1977 Corvette: Service Bulletin: Anti-Theft Alarm Switch - Protective Grease

Subject: Anti-Theft Alarm Switch - Protective Grease

Model and Year: 1977 Corvette

Bulletin No: 77-T-57

FIGURE #1 - DOOR LOCK/ANTI-THEFT SWITCH INSTALLATION

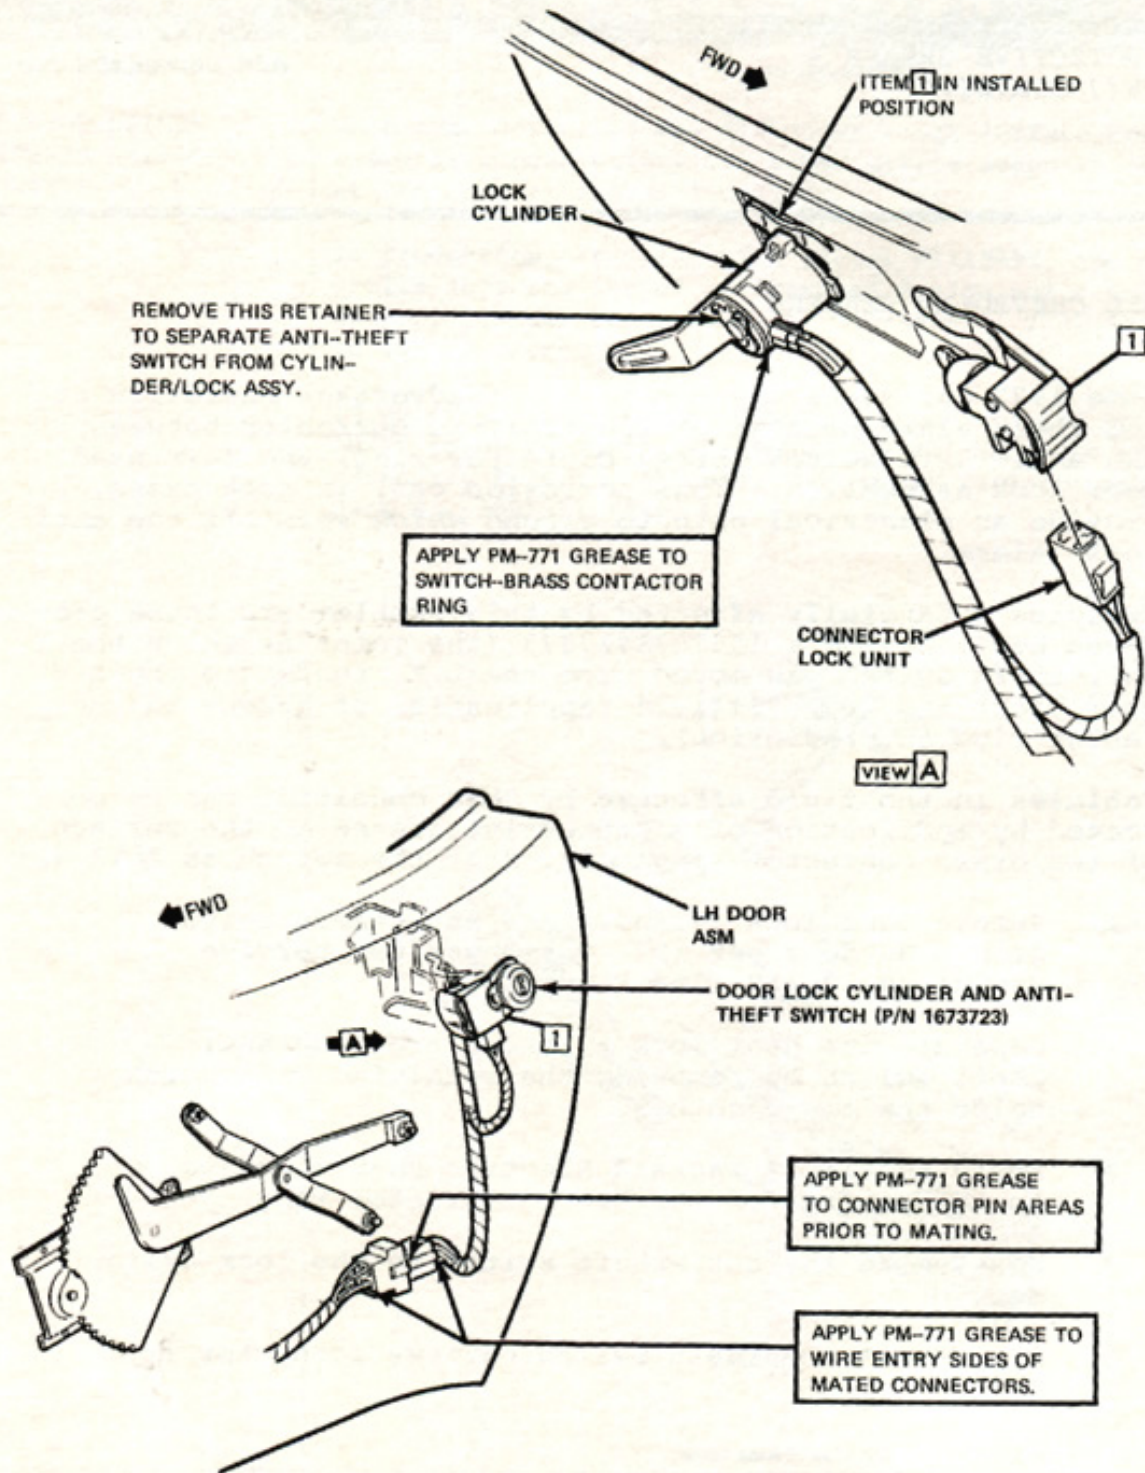
Some 1977 Corvettes may experience inadvertent operation of the theft alarm because of electrolytic corrosion between the anti-theft switch (brass contactor ring) and left hand door lock assemblies. This corrosion can, in some cases, provide an electrical path to ground which sets off the anti-theft alarm.

Vehicles potentially affected by this problem are those produced between VIN's 1Z37L7S427373 (the point at which the anti-theft switch was moved from the L.F. fender to the L.H. door lock) and 1Z37L7S441024 (application of grease to contactor ring in production).

Vehicles in the field affected by this condition can be corrected by application of a protective grease to the surface of the brass contactor ring portion of the switch as follows:

1. Remove door lock cylinder and anti-theft switch from L.H. door per 1977 Passenger Car Service Manual pg. 2D-19 (See Figure 1).
2. Separate the door lock cylinder from the anti-theft switch by removing the retaining ring which holds the two together.
3. Apply a film of Packard Electric PM-771 grease to the surface of the

brass contactor ring.

4. Reassemble the anti-theft switch to the lock cylinder.
5. Disconnect the theft switch harness connector from the door wiring harness connector and apply the same grease to connector pin areas. Reassemble connectors and apply this grease to the wire entry sides of the mated connectors.
6. Reassemble the door lock cylinder and anti-theft switch to the L.H. door per Service Manual instructions.

A satisfactory substitute for Packard Electric PM-771 grease is GM P/N 1050109 or 1050110.
